APPROVED DRAWINGS HAVE BEEN RED LINED INDICATING A CHANGE TO MEET THE OBC. PLEASE REVIEW ALL PAGES TO ENSURE YOU ARE PROPERLY INFORMED OF CHANGES.

Tice River Homes  
Legacy

project  
**Legacy**

model  
**SD-02**

A1

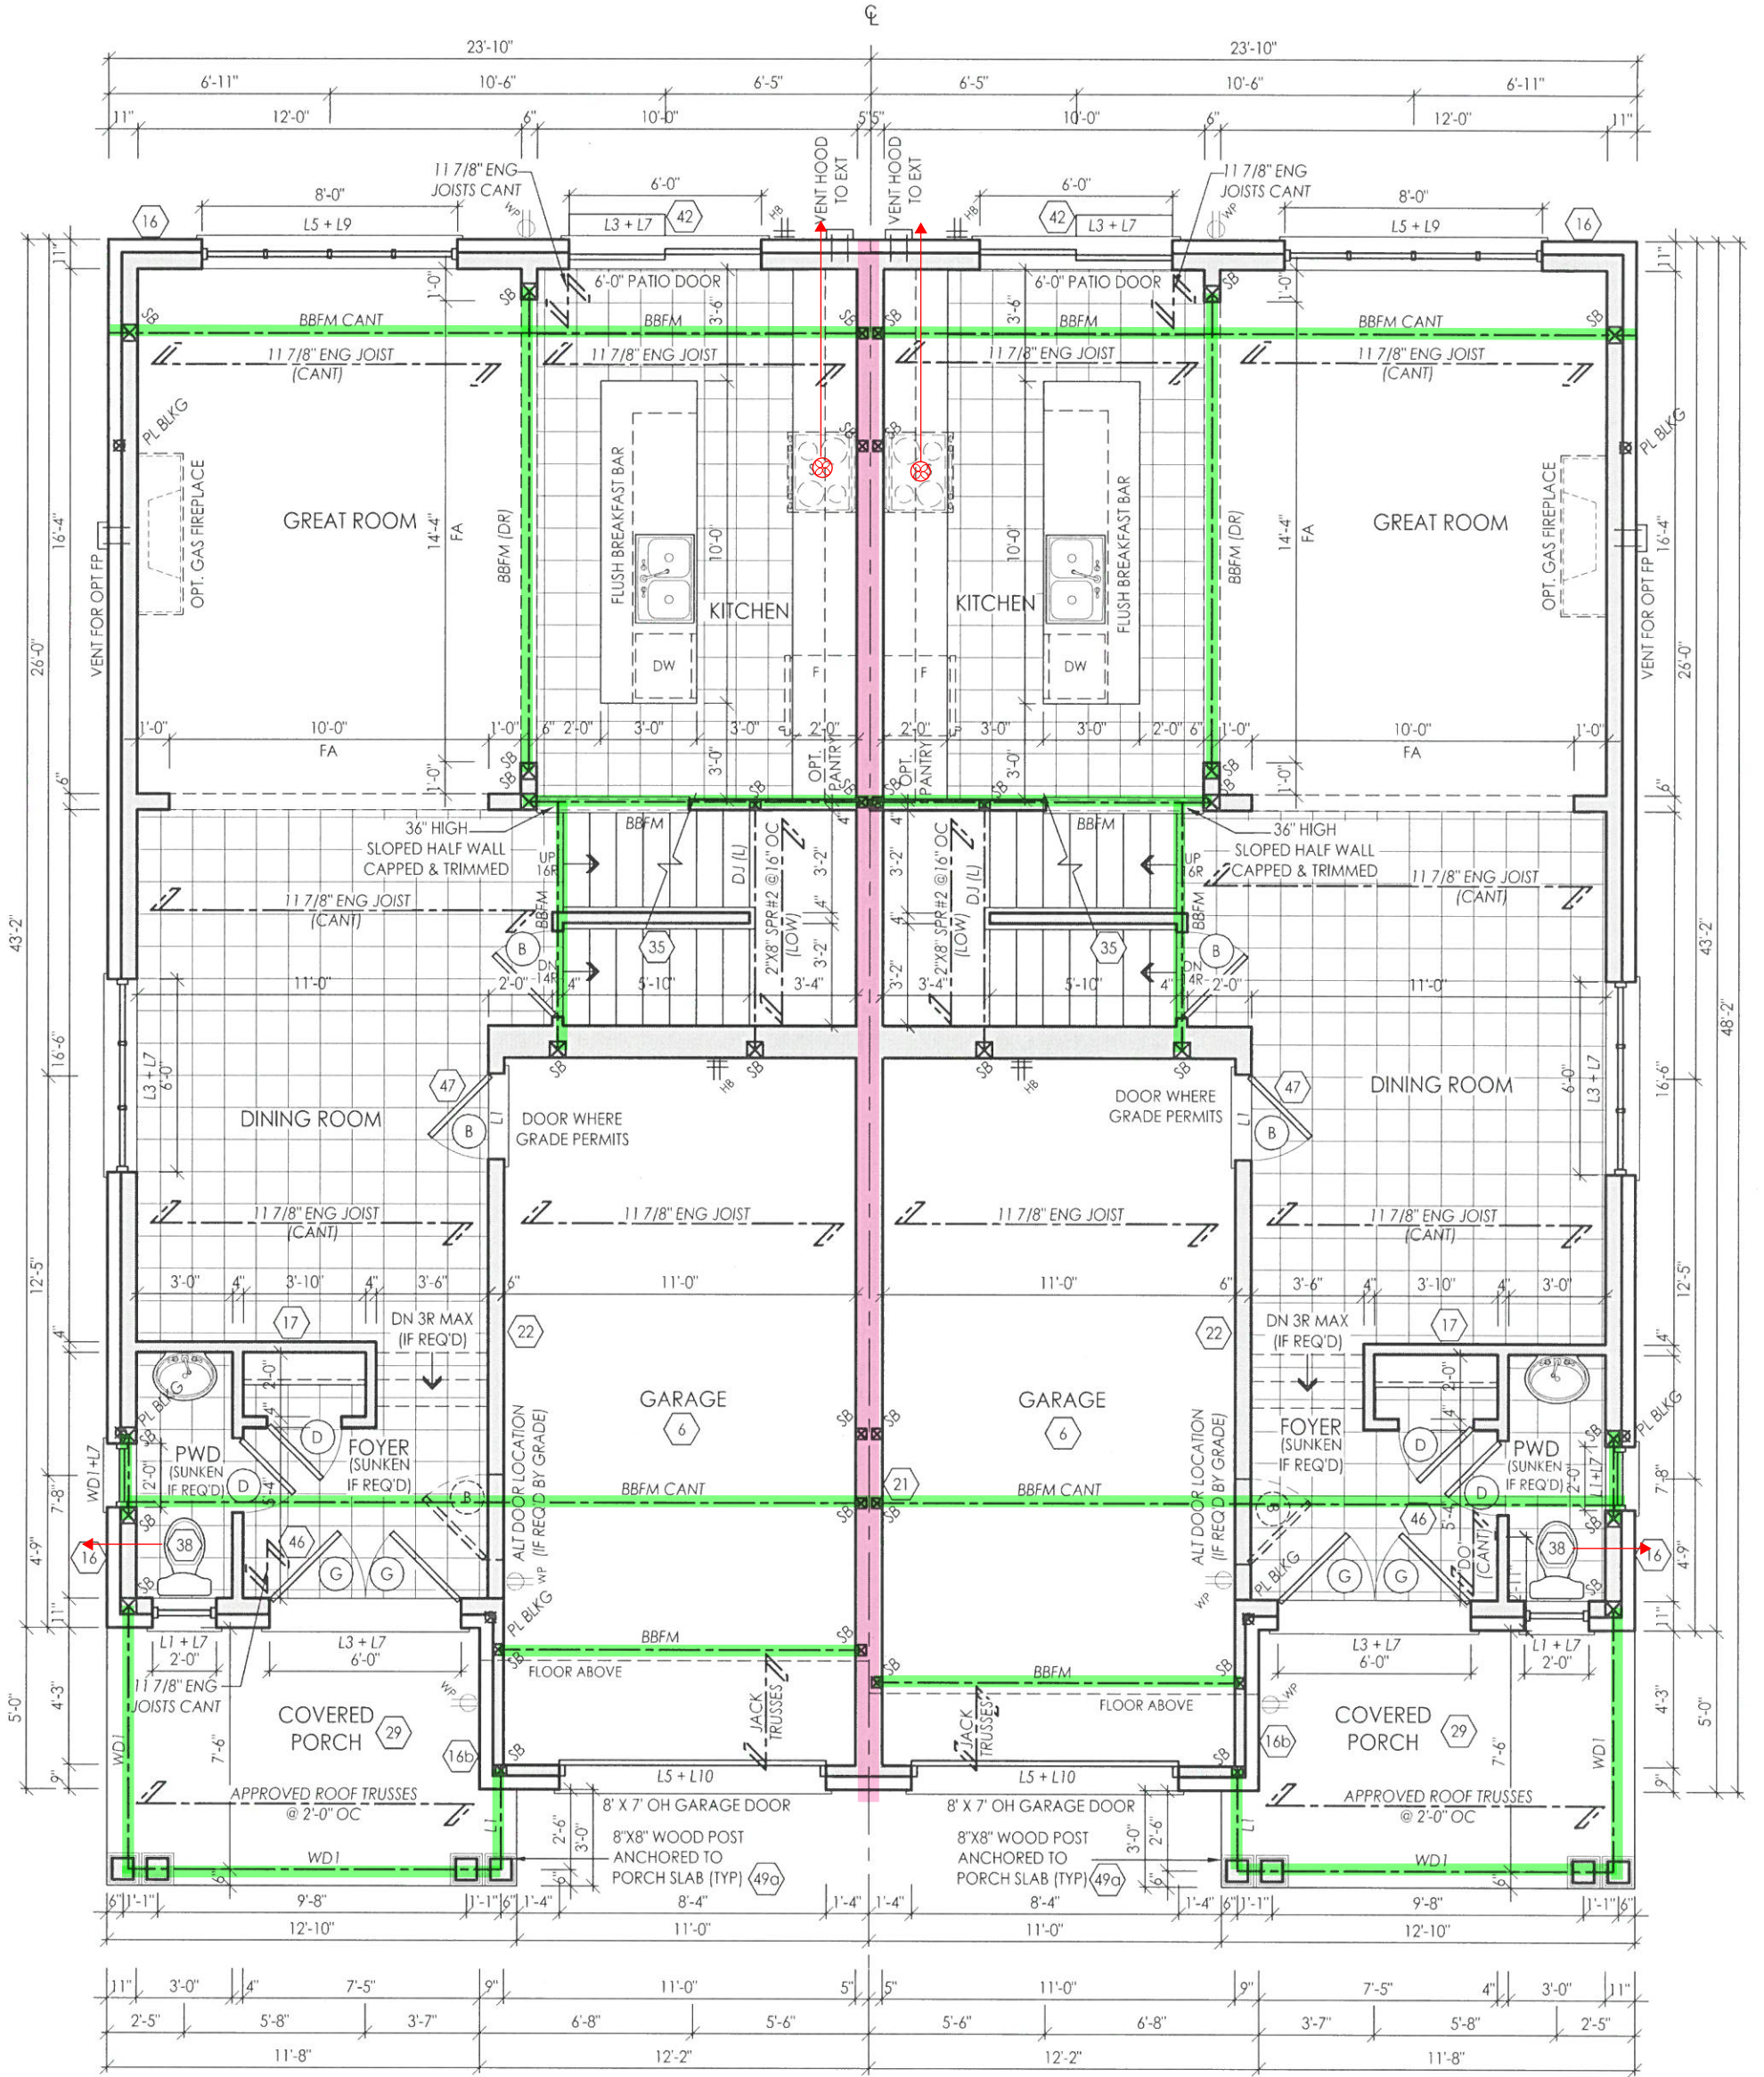
**TIGHTLY FIT ELECTRICAL BOXES WHERE BOXES ARE LOCATED ON BOTH SIDES OF WALL PROVIDING A F.R.R., OFFSET BOXES AT LEAST ONE STD SPACE TO MAINTAIN INTEGRITY OF FIRE SEPARATION.**

**A2**

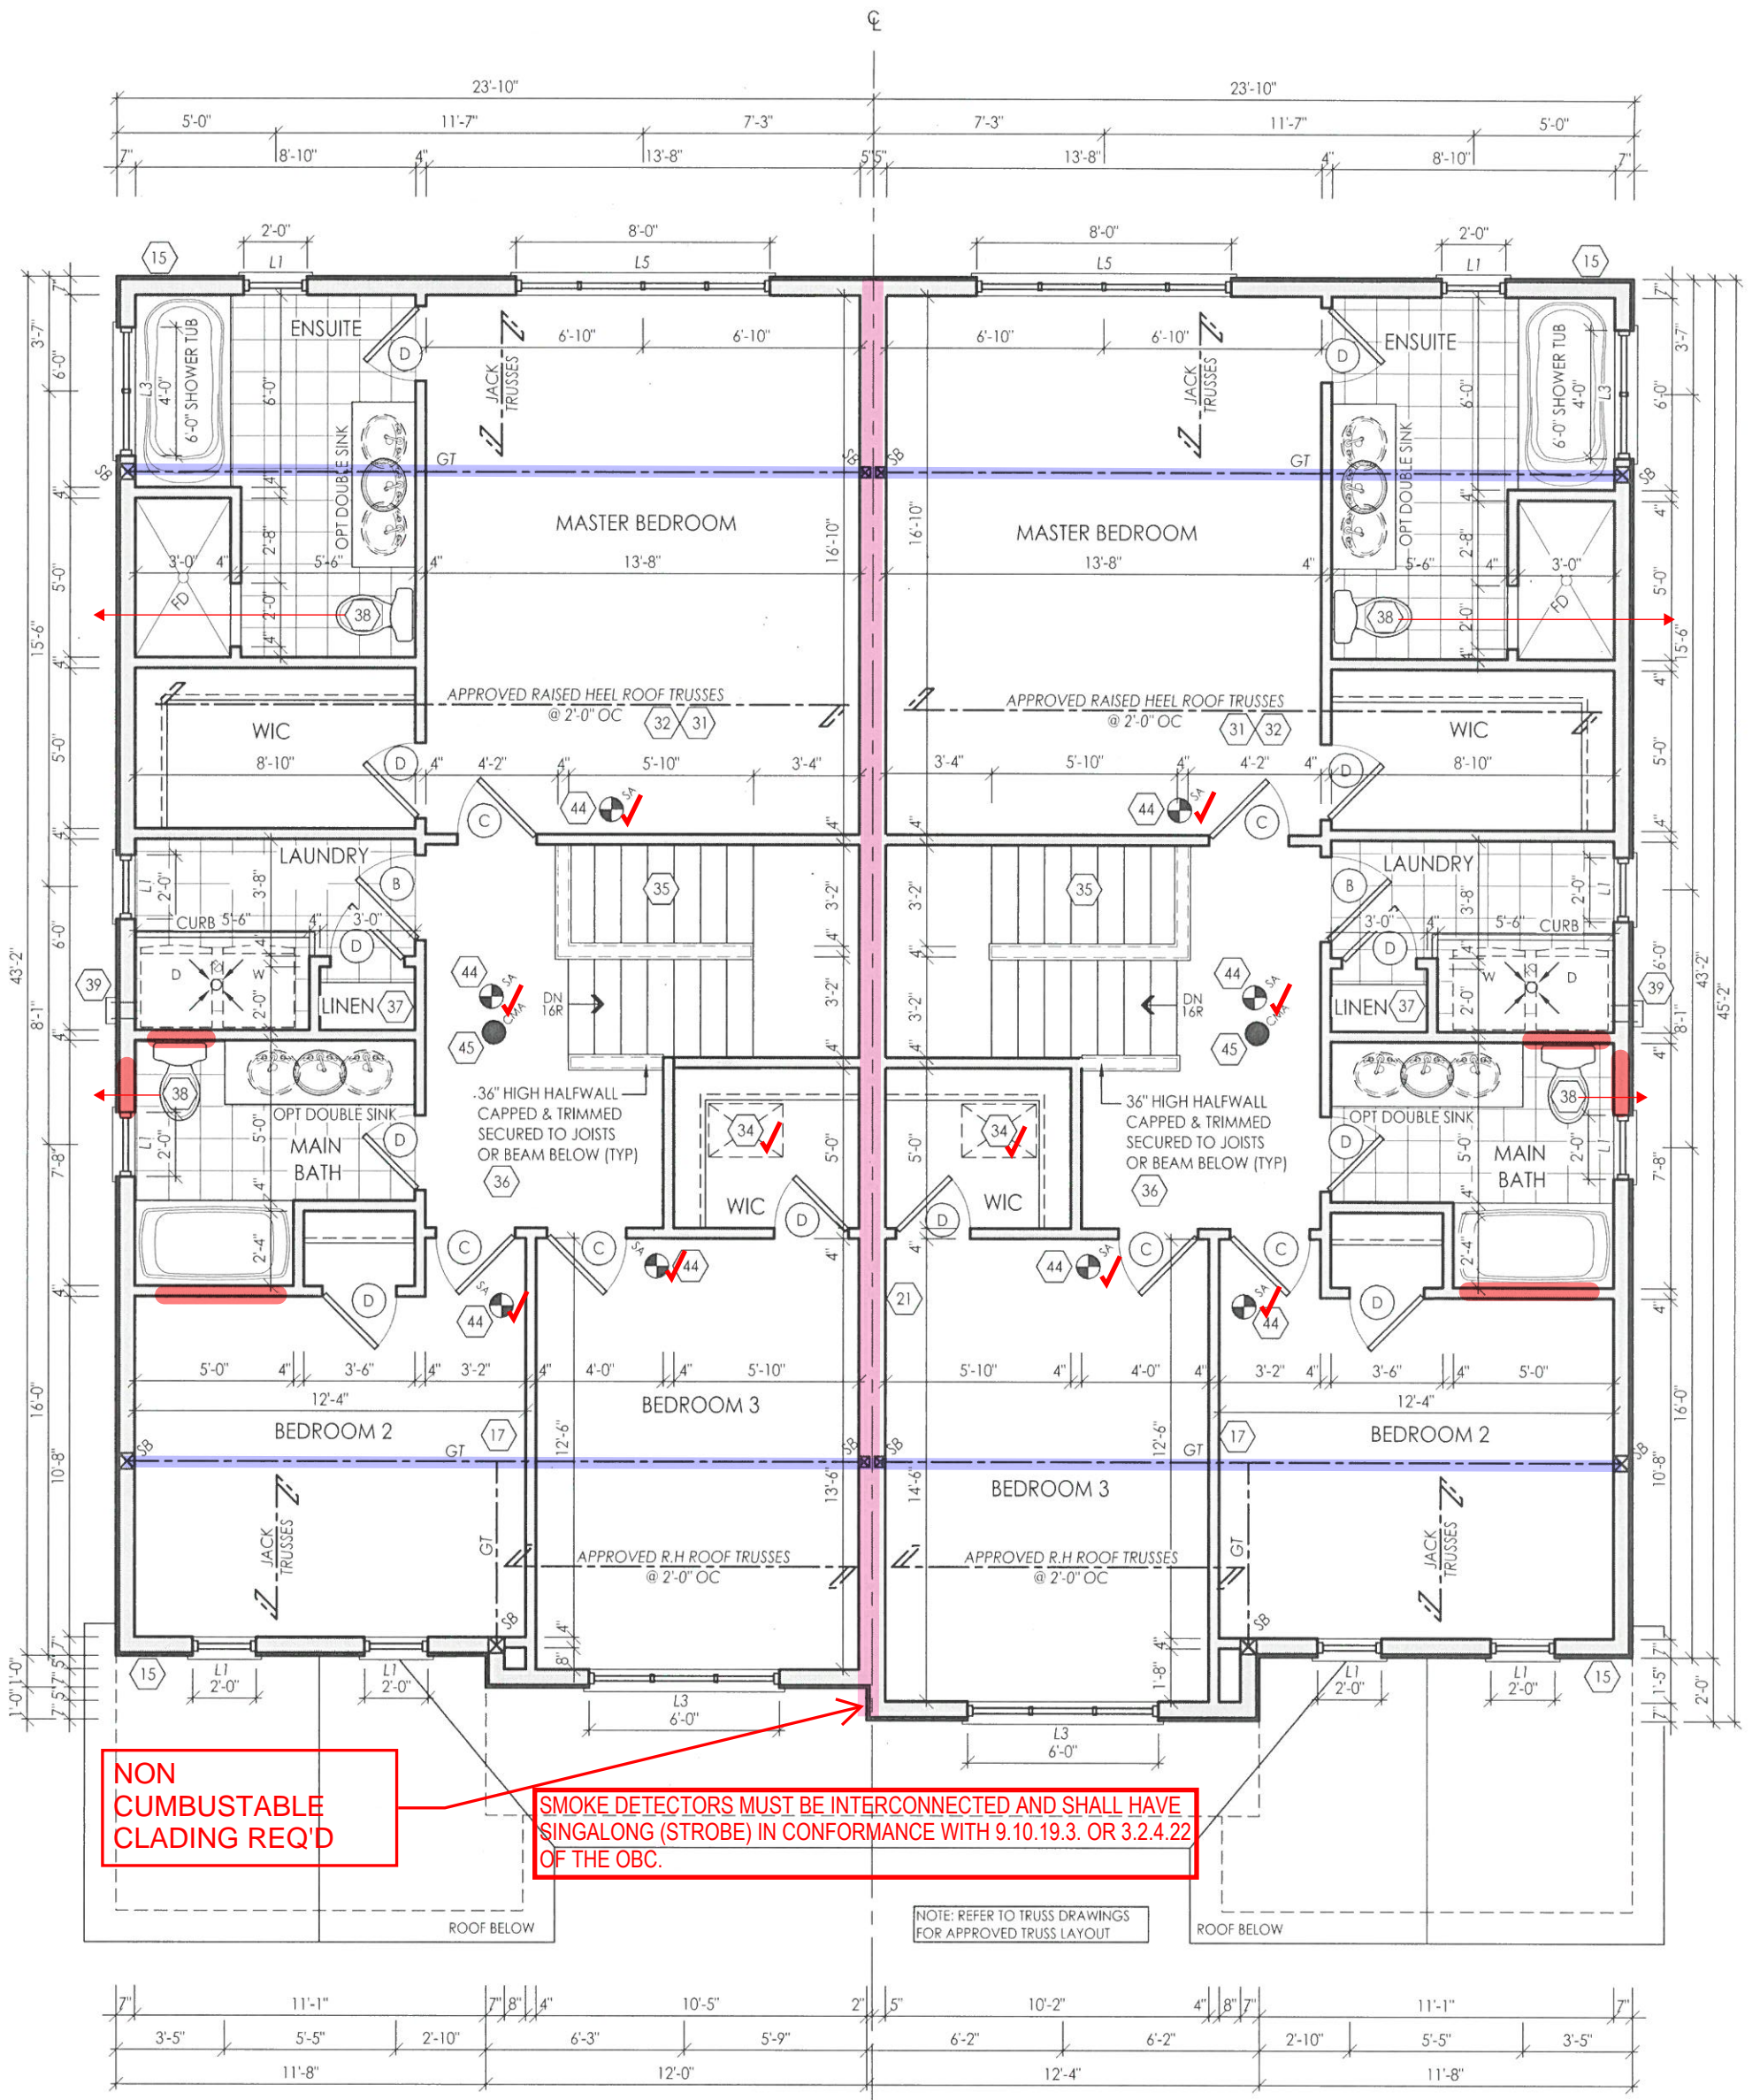
**NON CUMBUSTABLE CLADING REQ'D**

**SMOKE DETECTORS MUST BE INTERCONNECTED AND SHALL HAVE SINGALONG (STROBE) IN CONFORMANCE WITH 9.10.19.3. OR 3.2.4.22 OF THE OBC.**

**REINFORCEMENT IS REQUIRED FOR THE FUTURE INSTALLATION OF GRAB BARS FOR THE TOILET, SHOWER AND BATHTUB IN THE MAIN BATHROOM AS PER OBC 3.3.4.9.**
